DOMINION NUCLEAR CONNECTICUT, INC.
MILLSTONE POWER STATION UNITS 2 AND 3
SIX-MONTH STATUS REPORT IN RESPONSE TO MARCH 12, 2012 COMMISSION
ORDER MODIFYING LICENSES WITH REGARD TO REQUIREMENTS FOR MITIGATION
STRATEGIES FOR BEYOND-DESIGN-BASIS EXTERNAL EVENTS
(ORDER NUMBER EA-12-049)

**Six Month Status Report for the Implementation of Order EA-12-049, Order
Modifying Licenses with Regard to Requirements for Mitigation Strategies for
Beyond-Design-Basis External Events**

Millstone Power Station Unit 2

Millstone Power Station Unit 3

FIGURE 4 (AUGUST 2013 UPDATE)
 RCS MAKEUP - MECHANICAL CONNECTIONS
 MILLSTONE UNIT 2

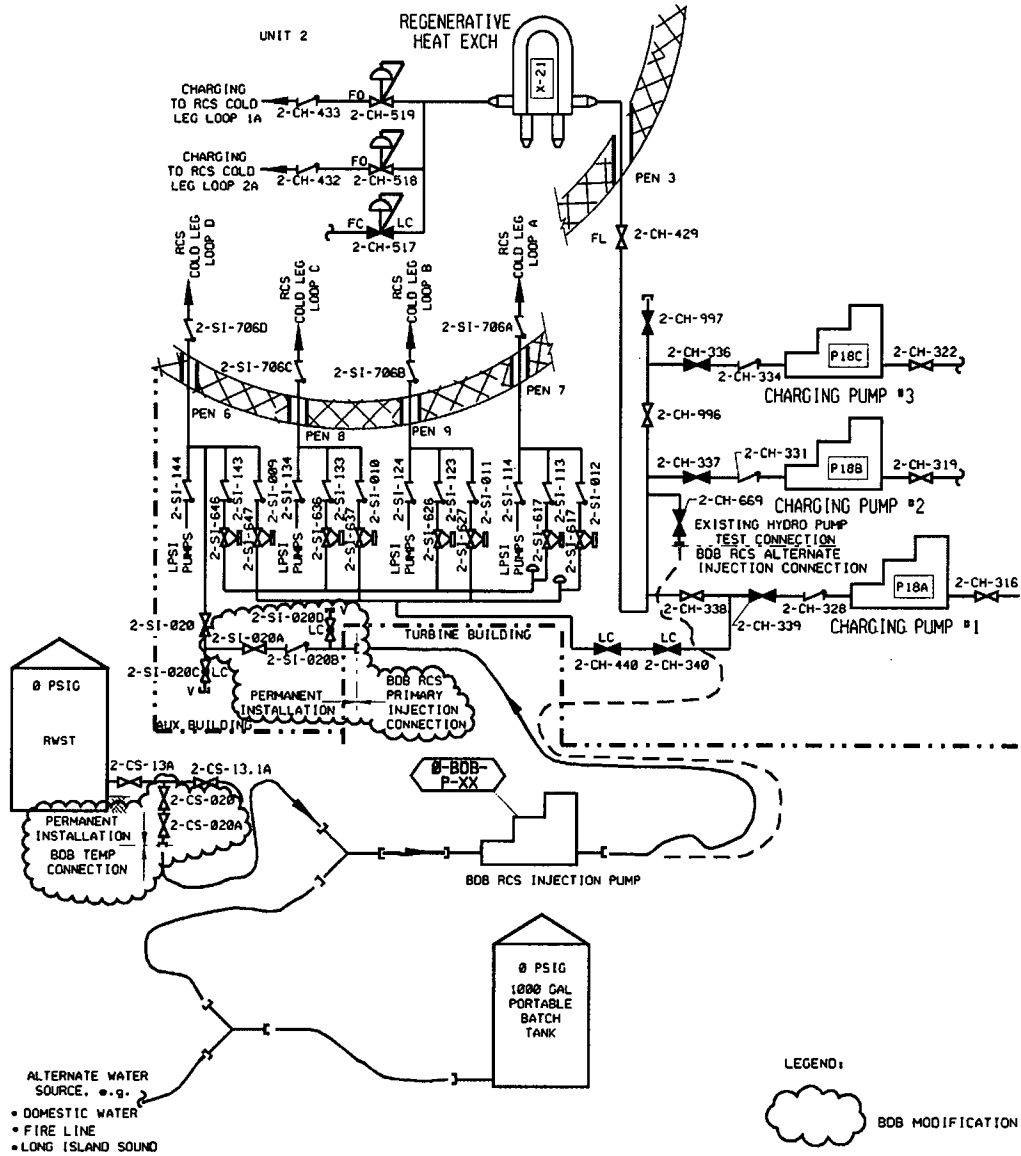
- d) Details of the alternate connection strategy for RCS injection, as described in Section C.2 – PWR Portable Equipment Phase 2, for use with the BDB RCS Injection pump have changed for MPS2. The discharge crosstie valve between the “A” charging pump and the “B” and “C” charging pumps, 2-CH-338, will no longer be used as the alternate connection for the BDB RCS Injection pump. The piping upstream of this original alternate connection has been determined to not be designed to withstand the discharge pressure of the BDB RCS Injection pump. Consequently, the alternate RCS injection connection will use the hydrostatic test connection in the charging header. A revised Figure 4 showing the new alternate RCS injection connection is attached.

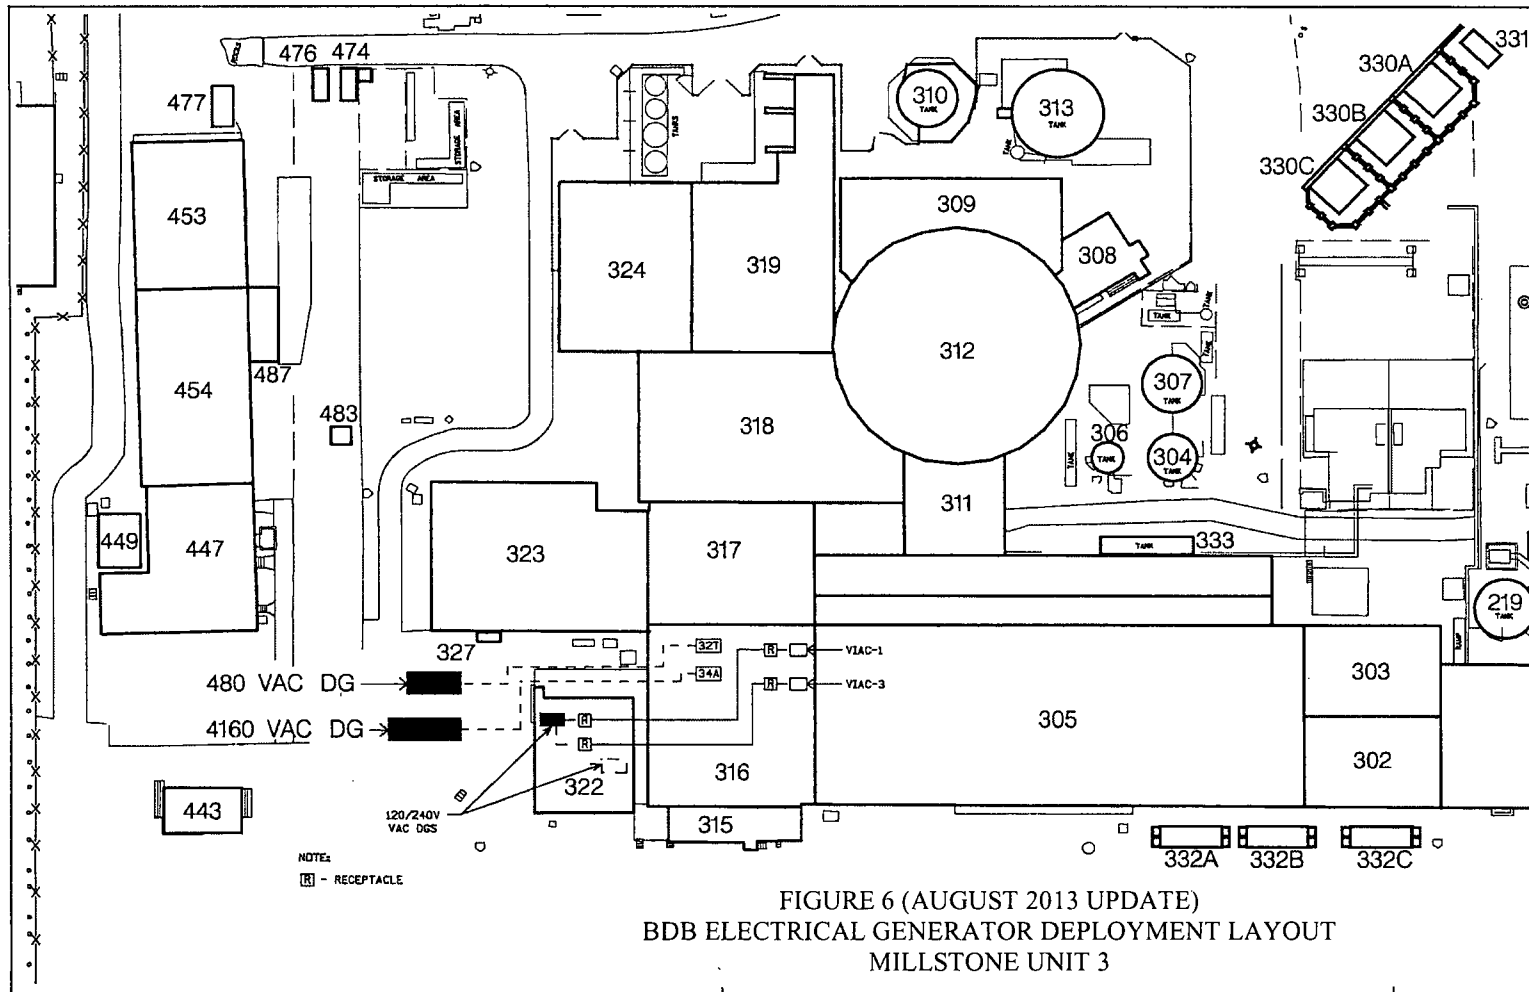
The connection strategy is changed in that permanently installed cables from receptacles located by the 120/240VAC DGs in Building 322 will be run to receptacles located in Switchgear Room "A." Additionally, receptacles will be permanently connected to the vital bus panels VIAC1 and VIAC3. Therefore, the connections between the DG and the nearby receptacles and between the Switchgear Room receptacles and the vital bus panels are made with plug-in "jumper cables". This configuration is shown on the revised OIP Figures 6 and 7 which are attached.

- b) With the changes to the 120/240VAC re-powering strategy above, the deployment strategy for the 480VAC DG has changed. The 480VAC DG, which is the alternate approach to re-power the 120VAC vital buses, will no longer be pre-staged. It will be stored in the BDB Storage Building and transported to its deployment location shown in

Figure 6, when needed. The revised battery life estimate for MPS3 has determined that there is adequate time to transport the 480VAC DG as an alternate for the 120/240VAC DGs (See Open Item No. 2). The 480VAC DG will be connected directly to Bus 32T via an installed spare breaker cubicle. A revised OIP Figure 8 showing the 480VAC connection is attached.
